Technical Bulletin

Model: Iris2/Lilac2 (Controller E-310)			Dat	te: 21-Mar-	01	No.: RB017008
Subject: E-310 Ver.1.1 (128MB) model release			Prepared	by: Chi	sato Tsuji	
From: Technical Services Dept., GTS Division						
Classification:	Troubleshooting	⊠ Part info	orma	tion	Action	required
		☐ Electric	al		Service Service	ce manual revision
	☐ Paper path	☐ Transm	it/rec	eive	☐ Retrof	fit information
	Other ()

Model: Iris2/Lilac2 Controller E-310 Dat			e: 15-Nov-01	No.: RG938001	
Subject: "Please Wait", White Line Scans, etc.			Prepared by: Ci	nisato Tsuji	
From: Technical Services Dept., GTS Division					
Classification:		☐ Part info	orma	tion	on required
		☐ Electric	al	☐ Serv	rice manual revision
	☐ Paper path	☐ Transm	it/rec	eive	ofit information
	Other ()

Model: Iris2/Lilac2			Dat	e: 15-Oct-02	No.: RG938002			
Subject: E-310 System Version 1.11 Release Information				Prepared by: Chi	sato Tsuji			
From: Technical Services sec. Service Planning Dept.								
Classification:	☐ Troubleshooting	☐ Part info	ormat	tion 🖂 Action	required			
	☐ Mechanical	☐ Electric	al	☐ Service	e manual revision			
	☐ Paper path	☐ Transm	it/rec	eive	fit information

Figure 4 -96 pin High Density connector

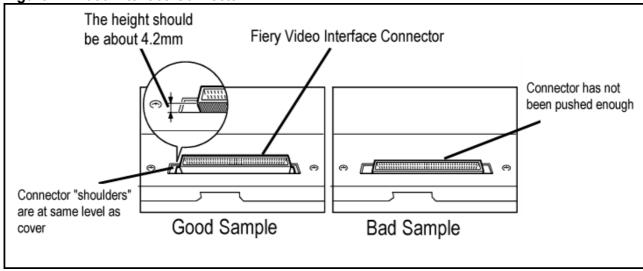
Incomplete connection between the copier interface and Fiery controller.

When there is an incomplete connection between the interface and controller, sometimes the controller does not receive the engine interface signals and/or the proper amount of power. In addition to the above symptoms, in the worst case the controller software can be damaged. Also, improper engine shutdown with an incomplete connection can cause a hard drive failure, as a subsequent power On will prevent a normal boot-up or cause a freeze.

- 1. Some units were shipped from the factory with the connector in the condition shown in Fig. A below, i.e. the connector was not sticking out at least 4.2mm from the unit (as it should).
- 2. The connector clears the unit side face by at least 4.2mm, but the controller unit was not inserted far enough into the interface unit at installation (Fig. 1-4 below).

- 1. Shut down the Fiery system and turn off the copier main power.
- 2. Pull out the Fiery controller unit and check to see if the video interface connector sticks out from the unit 4.2mm or more (Fig. A). If not, then follow the instructions in Fig. B below.
- 3. Fully reseat the controller all the way into the interface unit until the connector fully engages (Fig. 5, 6).
- 4. Turn on the copier main power.
